STAFF REPORT: PERMIT AMENDMENT

APPLICATION NUMBER: 5-98-156-A10

PROJECT LOCATION: 310 S. Pine Avenue, City of Long Beach, Los Angeles County.

DESCRIPTION OF CURRENT AMENDMENT REQUEST (5-98-156-A10):

COASTAL COMMISSION
 5-98-156-A10
 EXHIBIT # 4
 PAGE 2 OF 2

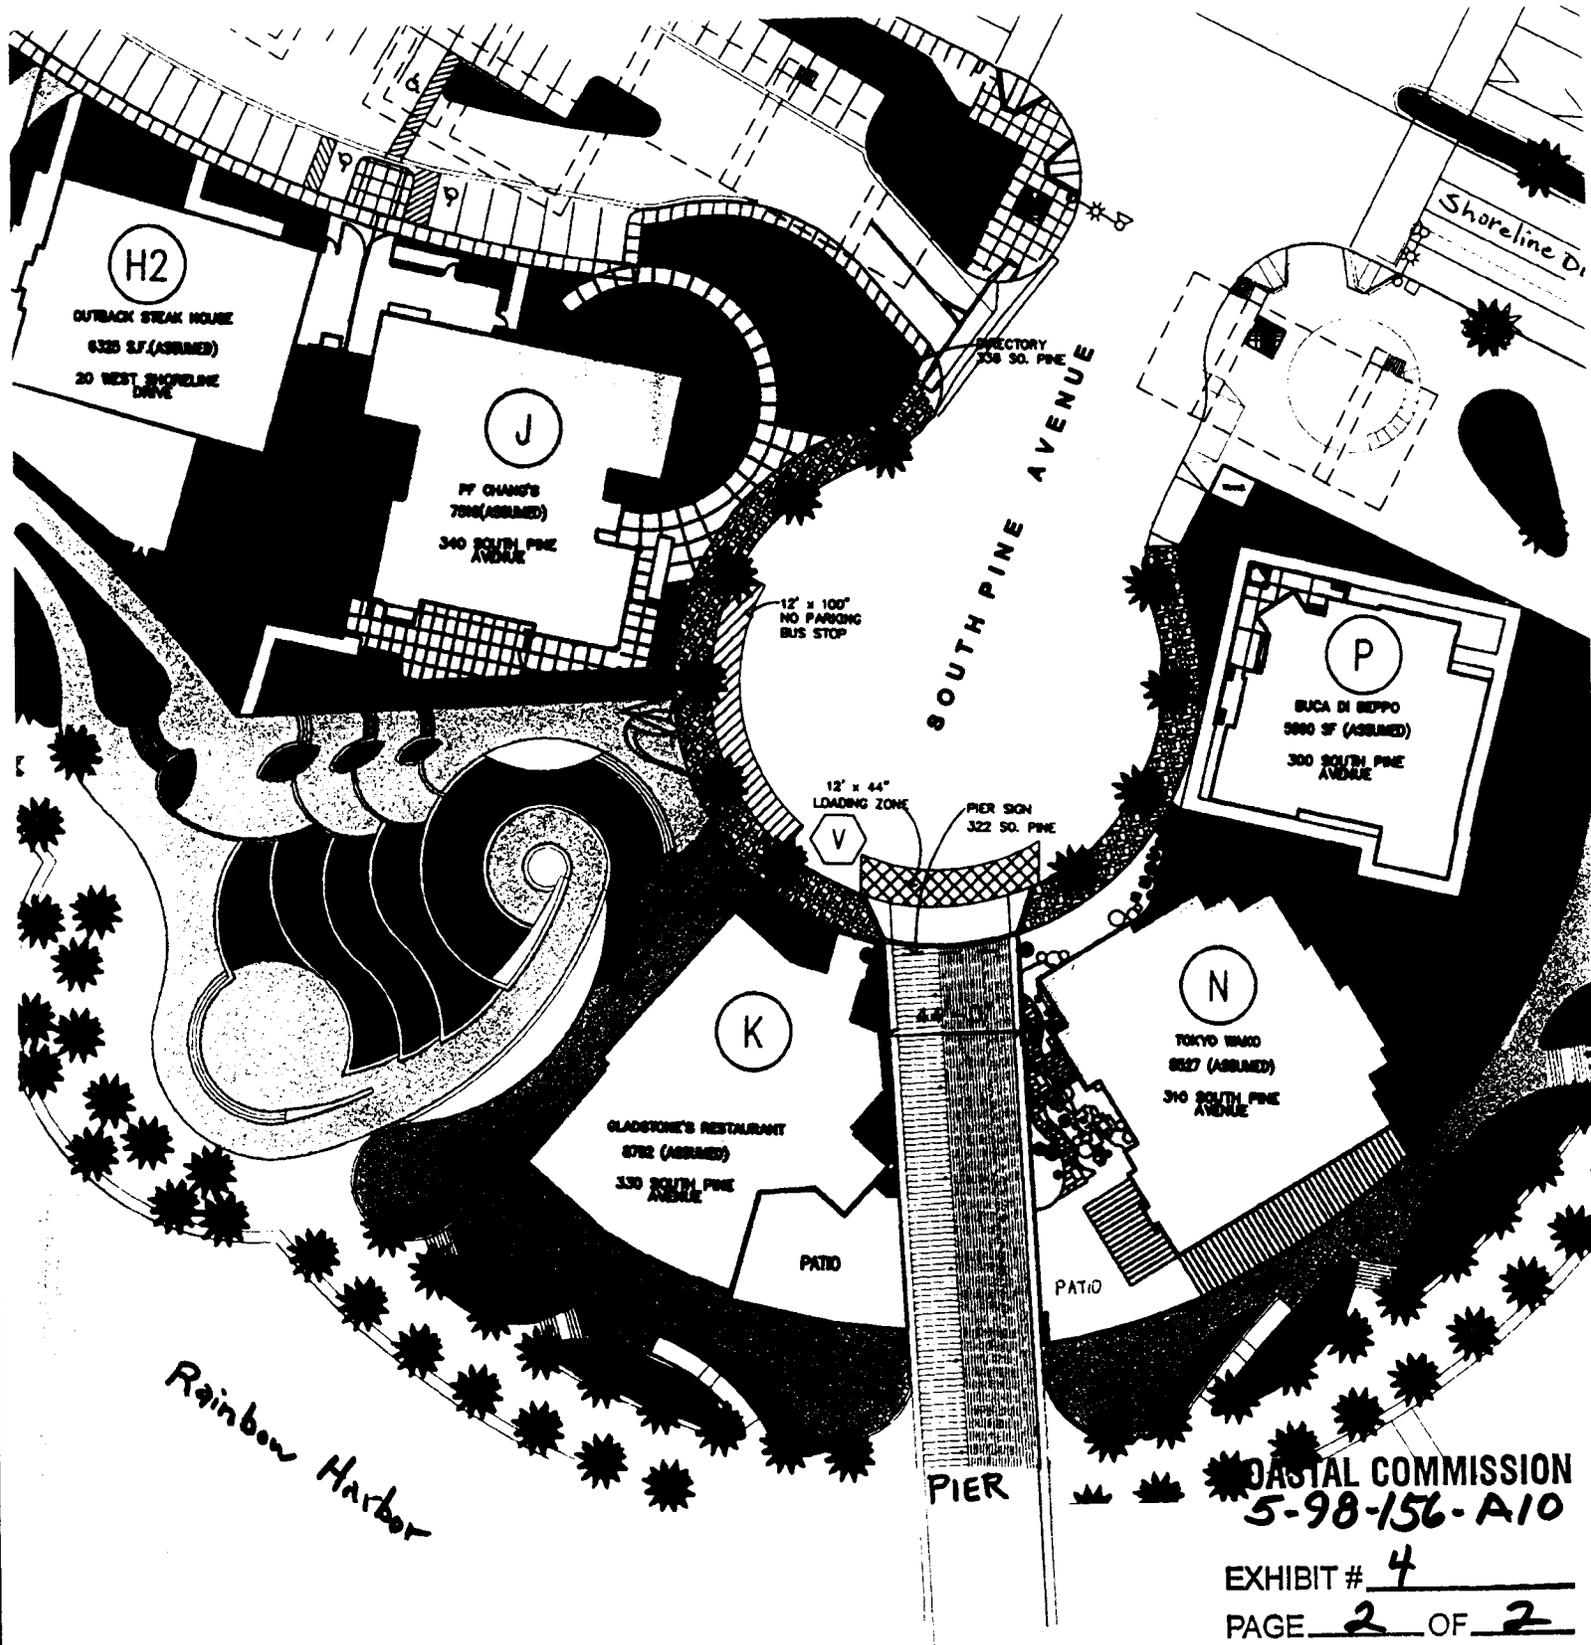
The previously approved site plan included three pad buildings along the east side of Pine Avenue Circle south of Shoreline Drive. The three building pads were designated M, N and P. Total square footage of the three buildings was approximately 21,684 square feet, with the building M being the smallest of the three, at approximately 3,280 square feet. The anticipated use for the "M" Building was a nautical themed museum. The original Museum tenant is no longer able lease this space. The other two pads were for restaurant uses with sit down dining and outdoor patios.

The City Of Long Beach and DDR Urban LP is requesting an amendment to the Development Permit to eliminate the 3,280 square foot "M" Building. The original three building pads will be replaced with two building pads designated "N" and "P". The two pad uses will be sit down type restaurants with inside and patio dining. The new "N" Building will be approximately 8,455 square feet with an additional 3,095 square feet of outdoor patio dining area, making a total size of 11,155 square feet. The "P" Building will be approximately 5,690 square feet in size. The elimination of the "M" Building will result in a reduction of total building square footage on the south side of Shoreline Drive. The previous plan had a total of 21,684 square feet for the three pads. The new plan has only 14,145 square feet of building area. This change will result in additional open area and landscaping adjacent to the two buildings and along the pier walkway serving the esplanade, marina and water front.

The new site plan eliminating the "M" Building enhances the project in the following ways:

**Building N
SITE PLAN**

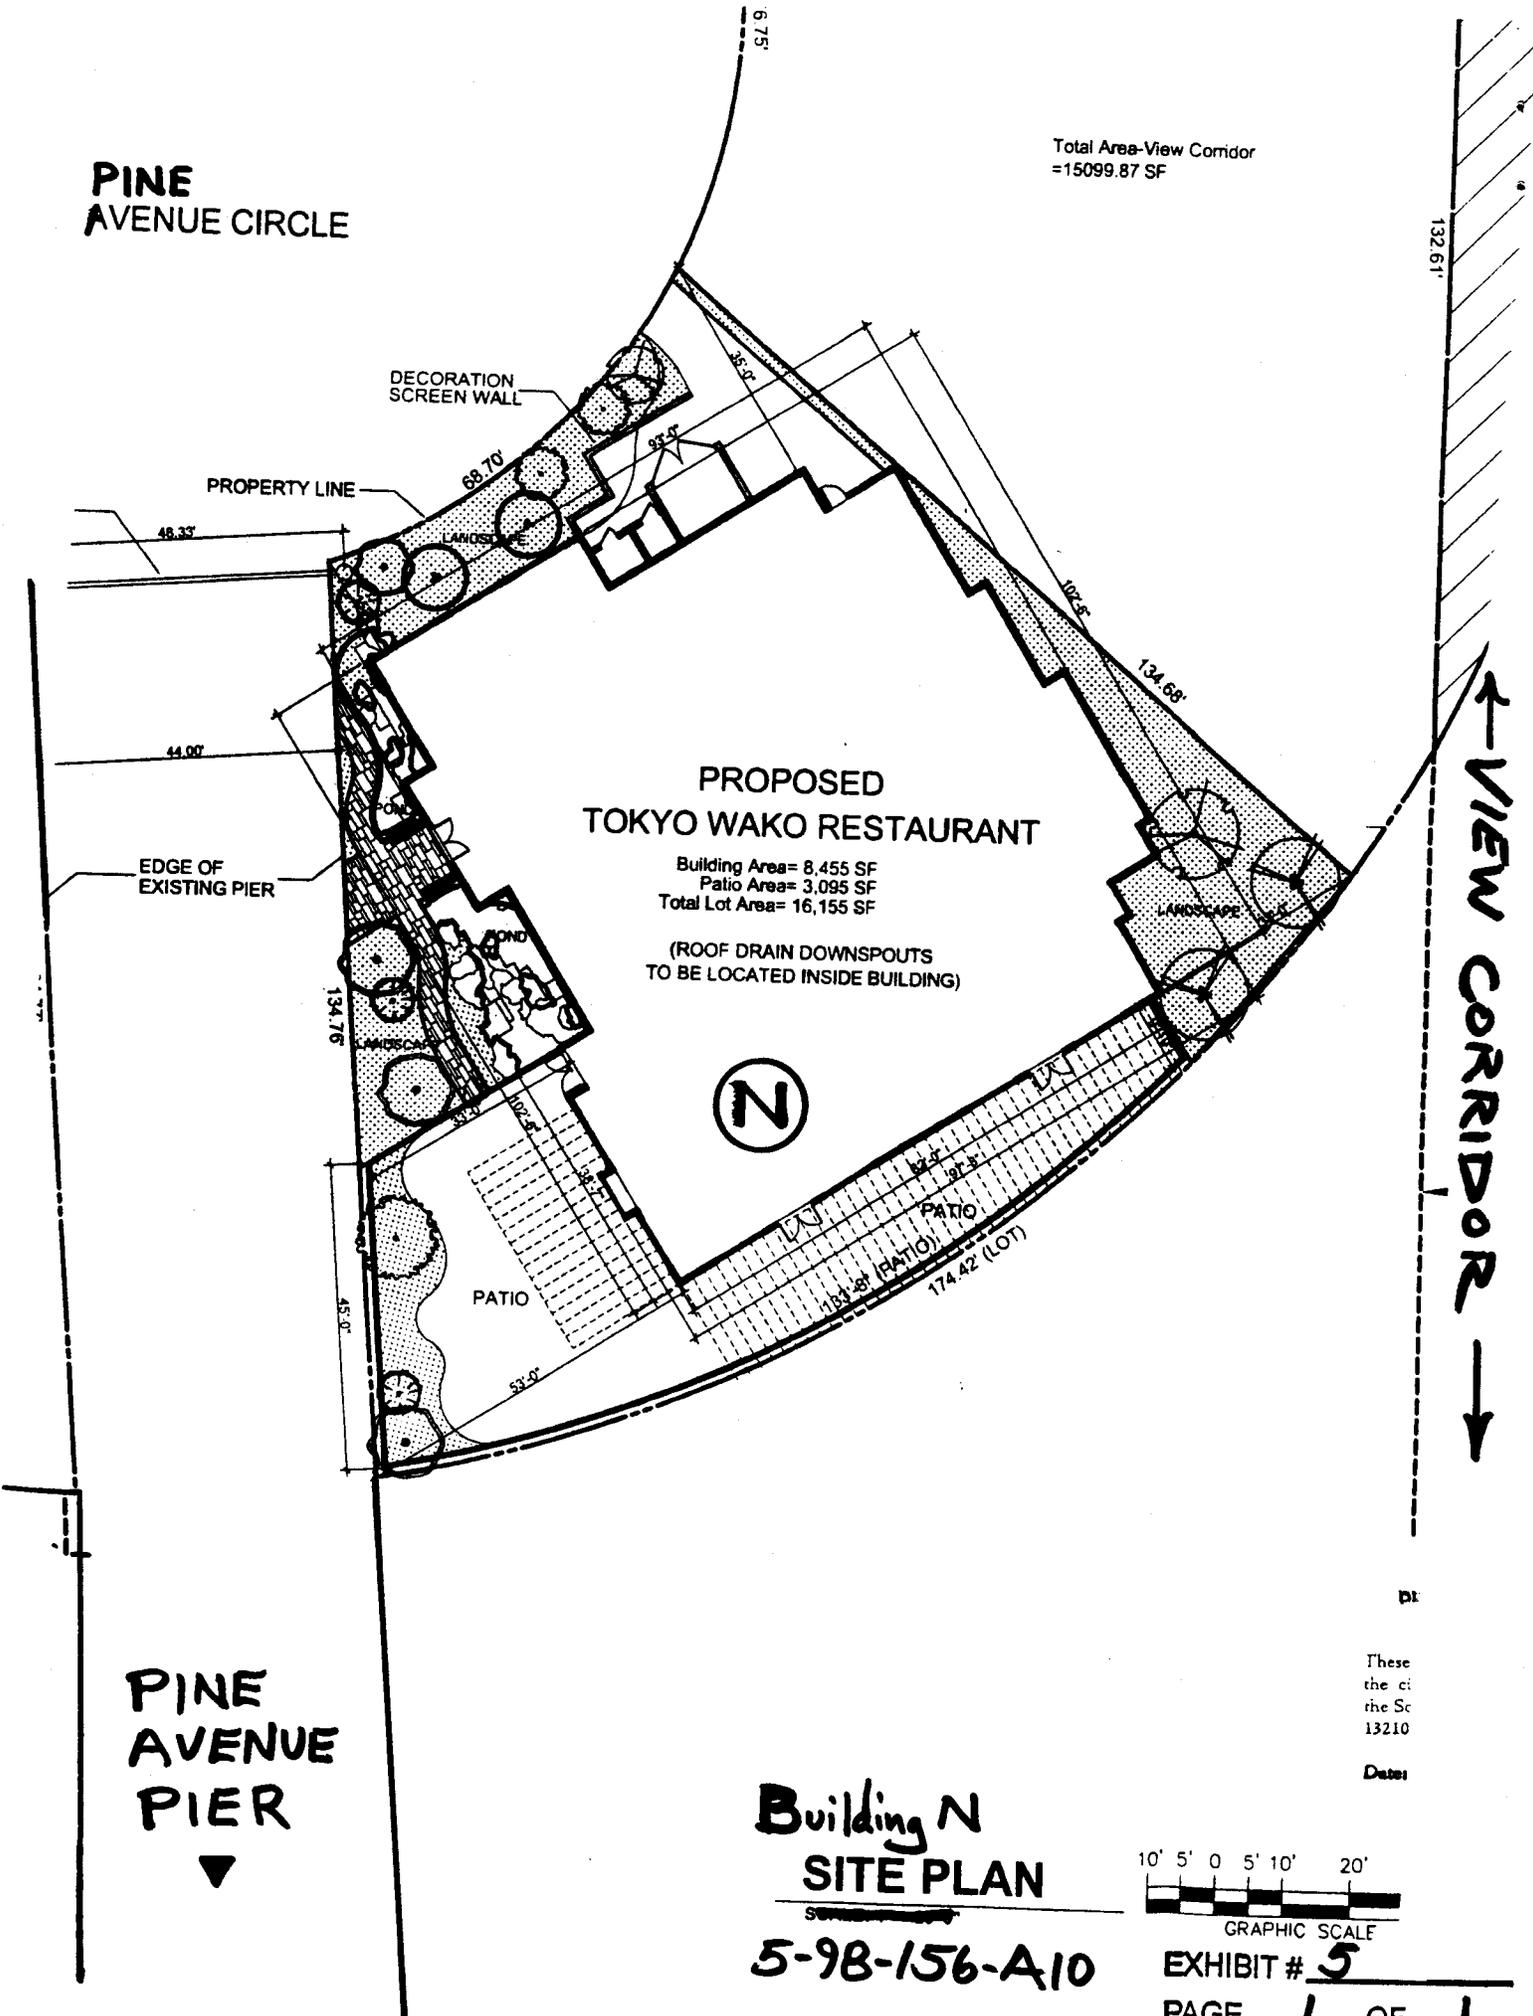
Delete the previously approved nautical museum (Building M) at the foot of Pine Avenue Pier, and incorporate the site into the adjacent restaurant use (Building N).

The co-applicants now state that a museum tenant is not able to lease the Building M space (Exhibit #4). Therefore, the co-applicants have requested Commission authorization to change the permitted use of the Building M site from museum to a restaurant dining patio. The Building M and N sites are currently vacant. As currently proposed, the site where the nautical museum would have been will be landscaped and used as an entry and outdoor dining patio for the restaurant use already approved on the Building N site (Exhibit #5). The result of the proposed change would be a reduction in the total building area and an increase in open space and landscaping next to the entrance to Pine Avenue Pier (Exhibit #4). The Building N restaurant plans are also being revised by this amendment to incorporate the former museum (Building M) site as part of the restaurant use (Exhibit #5).

New2. Final Plans: LCP Subarea 6 (Per Commission Approval of 5-98-156-A10, 1/14-16/04)

Prior to the commencement of construction of proposed Buildings G1, G2, H1 and H2, the applicants shall submit for the review and approval of the Executive Director, final site plans, floor plans and elevations. Buildings J, K and P are approved as shown on Exhibits #5-8 of the staff report dated 12/19/02. **Building N is approved as shown on Exhibits #5&6 of the staff report dated 12/17/03.** The plans for Buildings G1, G2, H1 and H2, and all commercial development in LCP Subarea 6 (Buildings F, G1, G2, H1, H2, J, K, N and P), shall comply with all of the following conditions:
